Title of Report:	Planning Committee Report – LA01/2022/0135/F
Committee Report Submitted To:	Planning Committee
Date of Meeting:	22nd March 2023
For Decision or For Information	For Decision

<u>No:</u>	LA01/2022/0135/F	<u>Ward:</u> Ballymoney East
<u>App Type:</u>	Full	
<u>Address:</u>	19 Church Street Ballymoney	
<u>Proposal:</u>	Extension to existing car sales compound.	
<u>Con Area:</u>	Ballymoney Town	<u>Valid Date:</u> 22.01.2021
<u>Listed Building Grade:</u>	N/A	
Agent:	Bell Architects Ltd 65 Main Street, Ballymoney. BT53 6AN	
Applicant:	Mr James Murray, 21 Church Street, Ballymoney.	
Objections: 0	Petitions of Objection: 0	
Support: 0	Petitions of Support: 0

- 4.1 This is a full application for a Proposed Change of Use and Renovation of Existing Building to Mixed Use Scheme of Office Space, Retail & 4 No. Apartments and all associated site works.

Bin & Waste Management Plan:

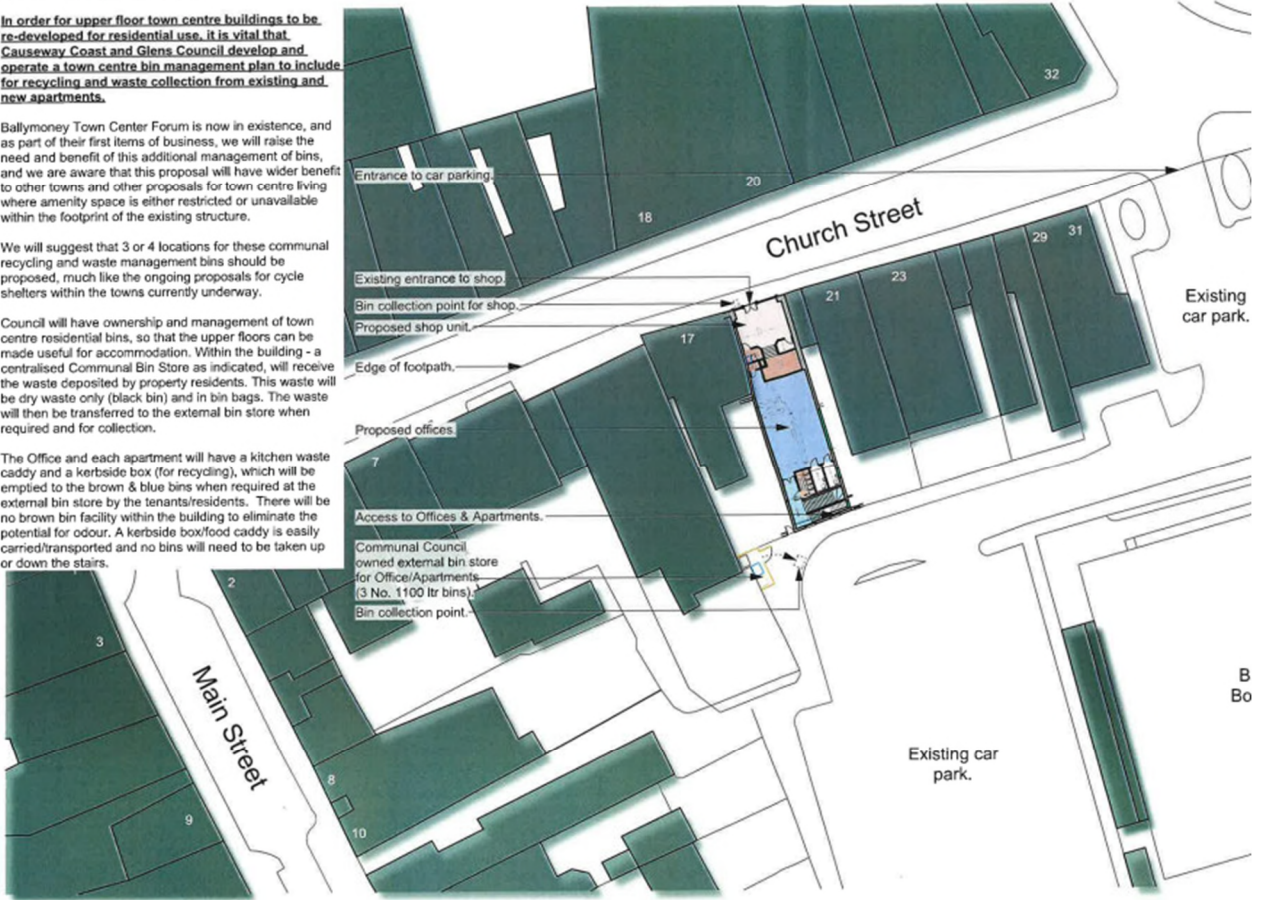
- 8.41 The scheme incorporates five 240l bins located on what is effectively the first floor (from the rear) to provide refuse facilities for dry waste only and are accessible via the stairwell raising significant issues around the practicality of their removal / emptying. For food waste /wet waste, the scheme relies on the use of small kitchen waste caddies to serve the apartments and office accommodation. As no on-site communal storage or refuse facilities are proposed, the agent suggests this issue could be addressed through the introduction of new Council delivered measures providing town centre recycling bins for town centre occupants at a number of locations. A bin and waste management plan has been submitted indicating the location of facilities within the public footpath to the south-west of the site and accessed from the public car park

- 8.44 In terms of the collection of dry waste the agent has suggested as part of the submitted bin and waste management plan that dry waste will also be transferred to the external bin storage facilities positioned on the public footpath as described above.

- 8.45 The external bin storage indicated (drawing 10) is located outside the proposed red line of the site and outside the applicants ownership. This would require permission / agreement with both DFI Roads and Council and raises issues regarding public accessibility and

ownership. The reliance on future, bespoke, refuse collection measures delivered by the Council demonstrates the shortfalls in the proposal due to overdevelopment and its failure to provide suitable waste facilities or a quality residential environment.

In order for upper floor town centre buildings to be re-developed for residential use, it is vital that Causeway Coast and Glens Council develop and operate a town centre bin management plan to include for recycling and waste collection from existing and new apartments.

Ballymoney Town Center Forum is now in existence, and as part of their first items of business, we will raise the need and benefit of this additional management of bins, and we are aware that this proposal will have wider benefit to other towns and other proposals for town centre living where amenity space is either restricted or unavailable within the footprint of the existing structure.

We will suggest that 3 or 4 locations for these communal recycling and waste management bins should be proposed, much like the ongoing proposals for cycle shelters within the towns currently underway.

Council will have ownership and management of town centre residential bins, so that the upper floors can be made useful for accommodation. Within the building - a centralised Communal Bin Store as indicated, will receive the waste deposited by property residents. This waste will be dry waste only (black bin) and in bin bags. The waste will then be transferred to the external bin store when required and for collection.

The Office and each apartment will have a kitchen waste caddy and a kerbside box (for recycling), which will be emptied to the brown & blue bins when required at the external bin store by the tenants/residents. There will be no brown bin facility within the building to eliminate the potential for odour. A kerbside box/food caddy is easily carried/transported and no bins will need to be taken up or down the stairs.
